SB-GA8-2014-116

Issue 3

Service Bulletin

Installation of a Secondary Starter Solenoid

Figure 2: View Looking Aft on Firewall

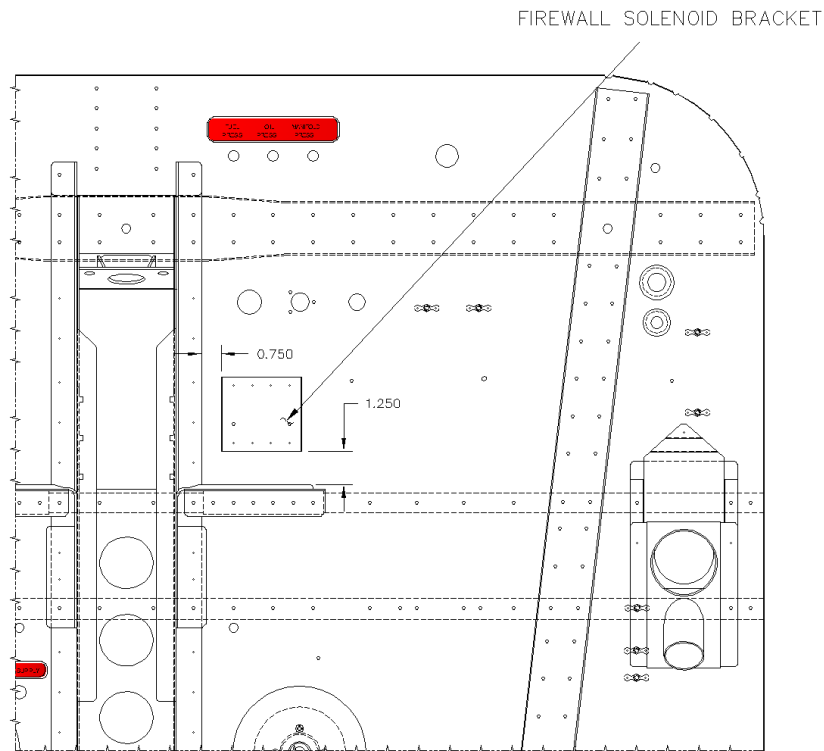
12.1.5 Place the Firewall Solenoid Bracket (item 1) in position as per Figure 2 and back drill the 8 x $\varnothing 0.098$ " bracket mounting holes through the firewall. Open holes up to $\varnothing 0.128$ " and clip in location.

Figure 7: P/No. STS-S12 Solenoid Modification

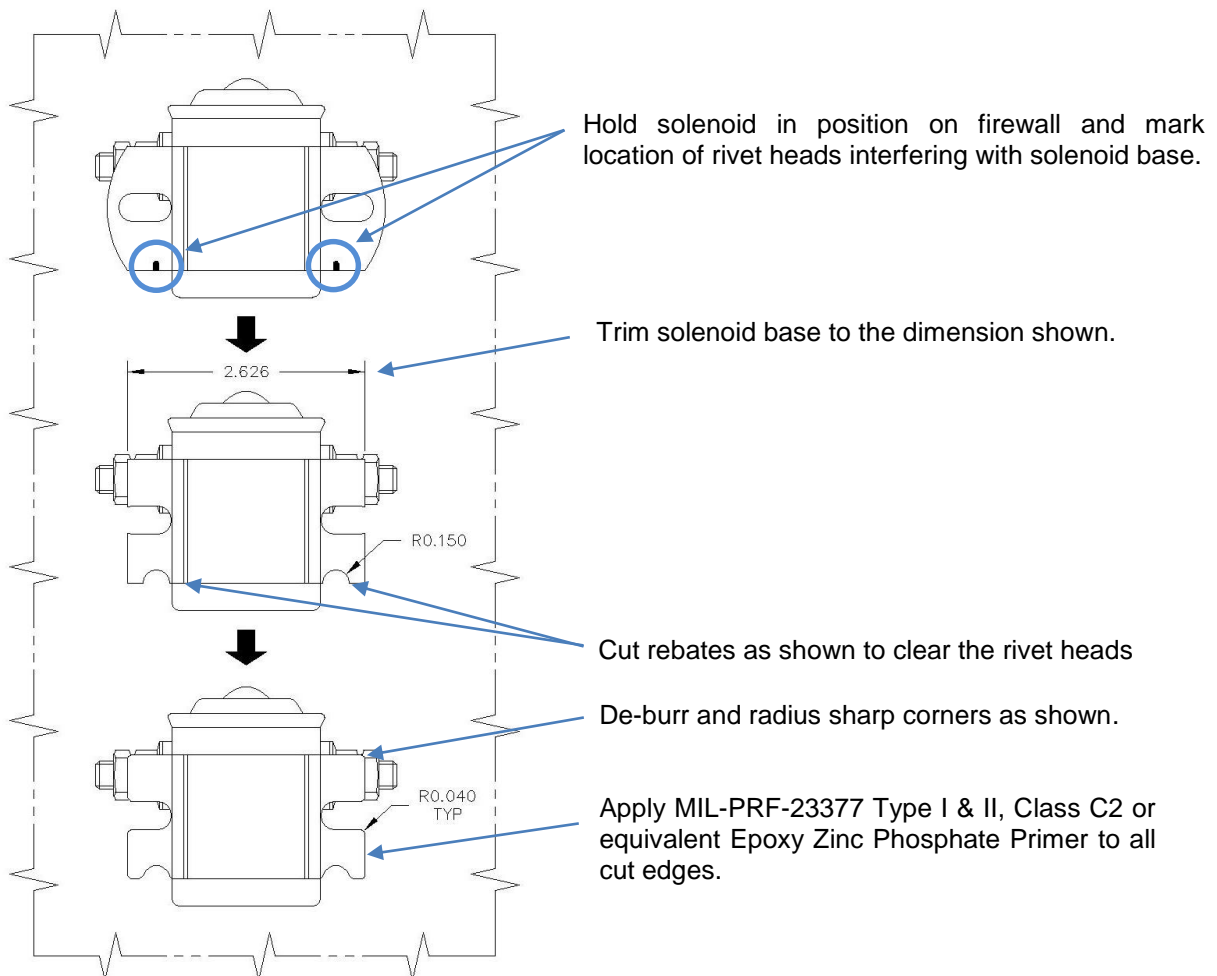
12.2.5 P/No. STS-S12 solenoids made by “Lamar Technologies” have slightly different mounting plates which may impact the solenoid mounting bracket in some cases. Where this occurs, the solenoid may be modified as detailed in Figure 7 below:

12.2.6 The modified solenoid may then be affixed to the firewall in accordance with the details provided in Sections 12.1.10 through 12.1.13.

Figure 8: Cable Routing, View Looking Inboard/Aft On Firewall LHS

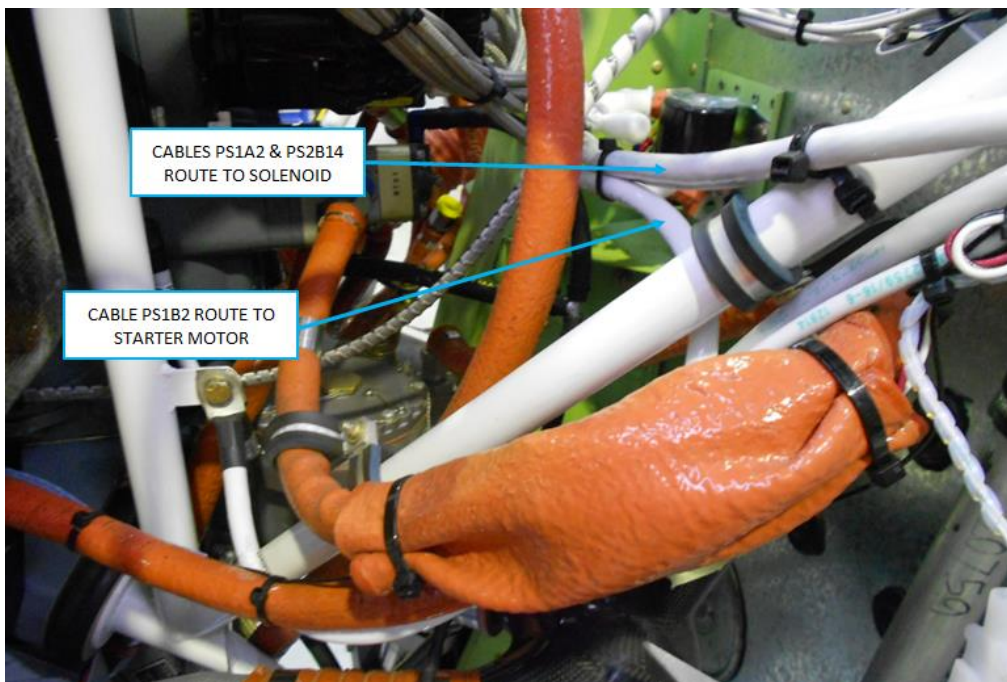
- 12.3.7 The cable assembled in Step 12.3.5 is to be inserted through the supplied Terminal nipple (Item 11) and attached to the respective terminal of the solenoid with the hardware supplied. Torque to 20in-lb.
- 12.3.8 Slide the Terminal nipple into position. Refer to Figure 8 for the cable routing for PS1A2 & PS2B14 from firewall to Solenoid.

- 12.3.9 Using the supplied 55" length of 2 AWG White ETFE (MS22759/16-2-9), crimp the terminal ring red (Item 12) and heat shrink the sleeve to both ends. Label the cable PS1B2.
- 12.3.10 Slide the cable PS1B2 assembled in step 12.3.9 through the fire sleeve forward to the engine starter motor and attach with the hardware retained in step 12.3.2. Pass the other end through the supplied terminal nipple (Item 10) and attach to the outboard terminal of the solenoid with the hardware supplied. Slide the terminal nipple into position. For routing details refer to Figure 8.

Figure 10: Modified Configuration

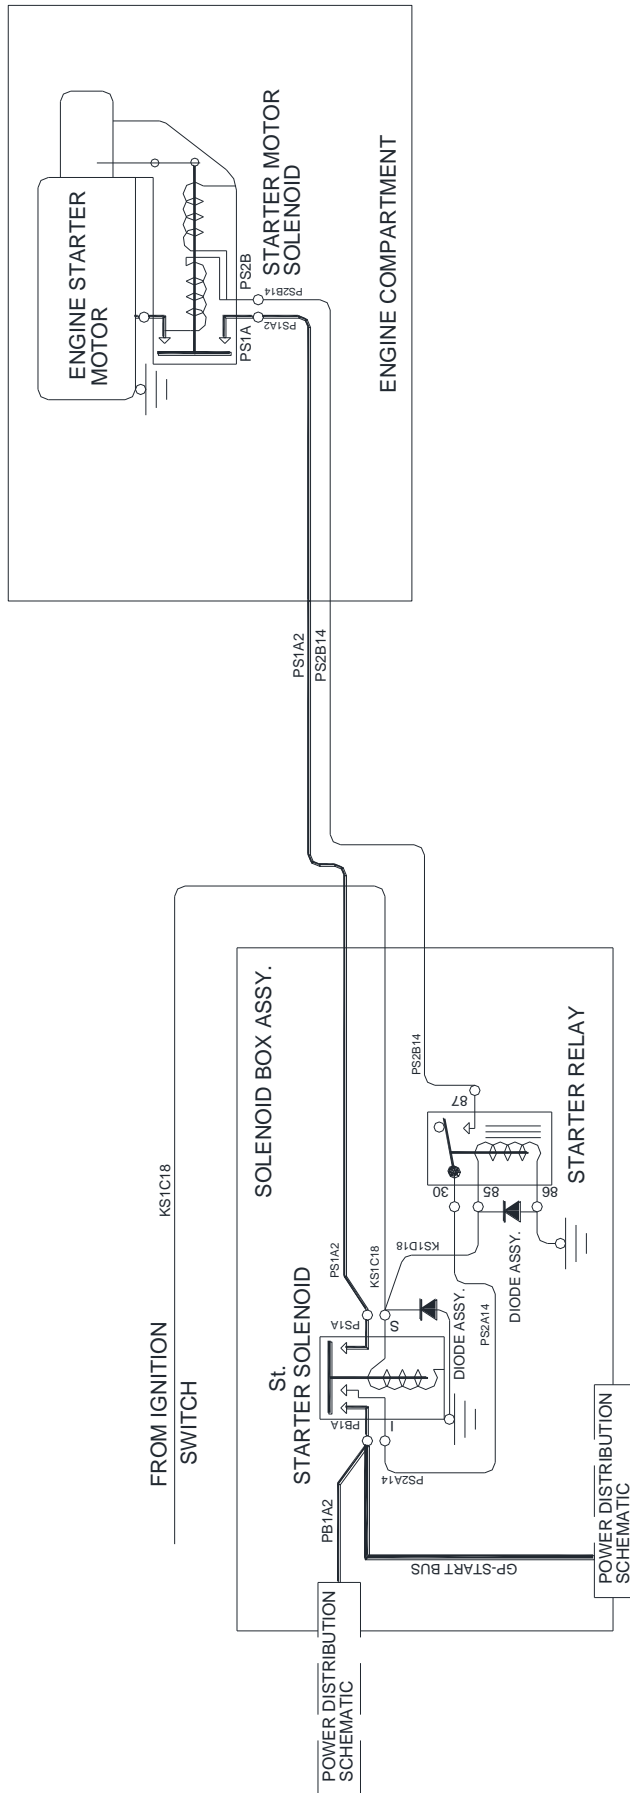
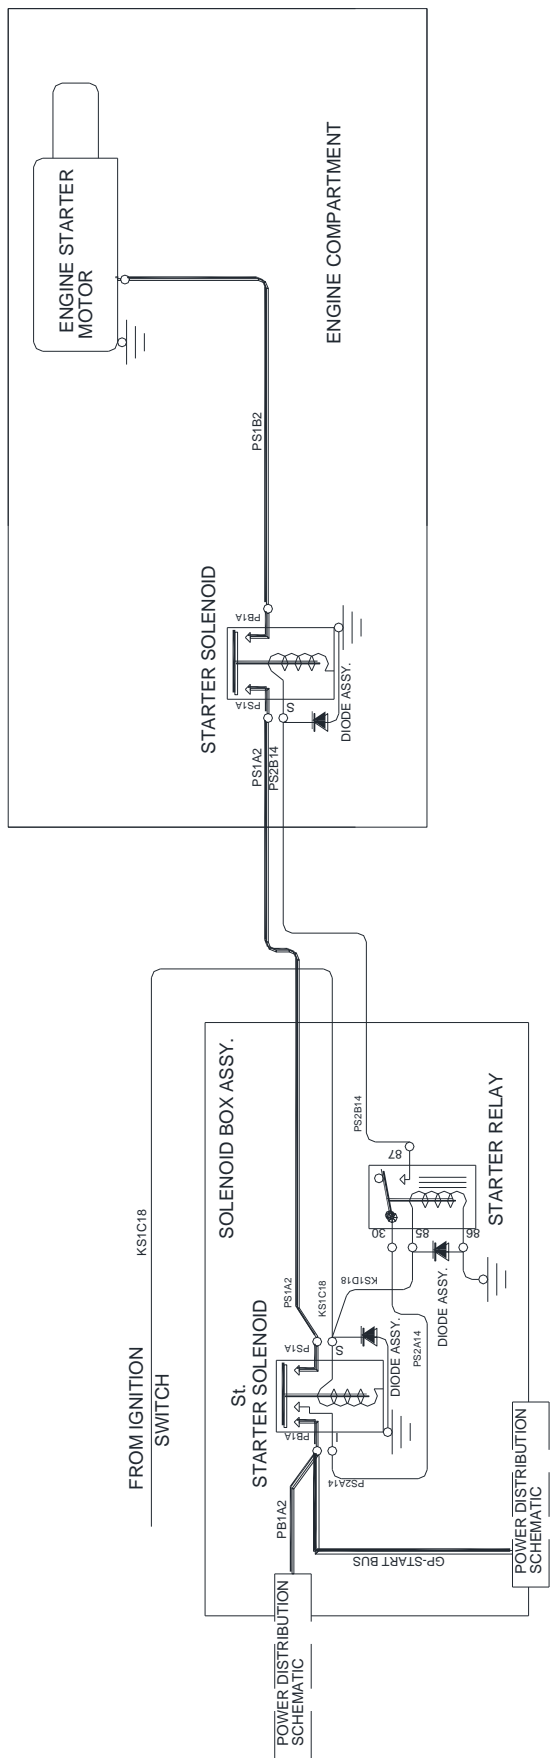
- 12.3.1 An overview of the original and modified wiring diagrams is shown in Figure 9 and Figure 10.
- 12.3.2 Refer to Figure 9, on the engine starter motor (mounted below the engine) locate the terminals PS1A & PS2B. Undo the cables attached to the terminals identified as PS1A2 & PS2B14. Retain hardware for reinstallation. Remove both cables through the existing fire sleeve back to the firewall.
- 12.3.3 Cut PS1A2 and PS2B14 to length for connection to newly installed solenoid.
- 12.3.4 Crimp the terminal ring (Item 12) to the PS1A2 cable and heat shrink the sleeve.
- 12.3.5 Crimp the terminal ring (item 13) to the PS2B14 cable and heat shrink the sleeve.
- 12.3.6 Pass the cable assembled in Step 12.3.4 through the supplied Terminal nipple (Item 10) and attached to the respective terminal of the Solenoid with the hardware supplied. Torque the nuts to 40in-lb.
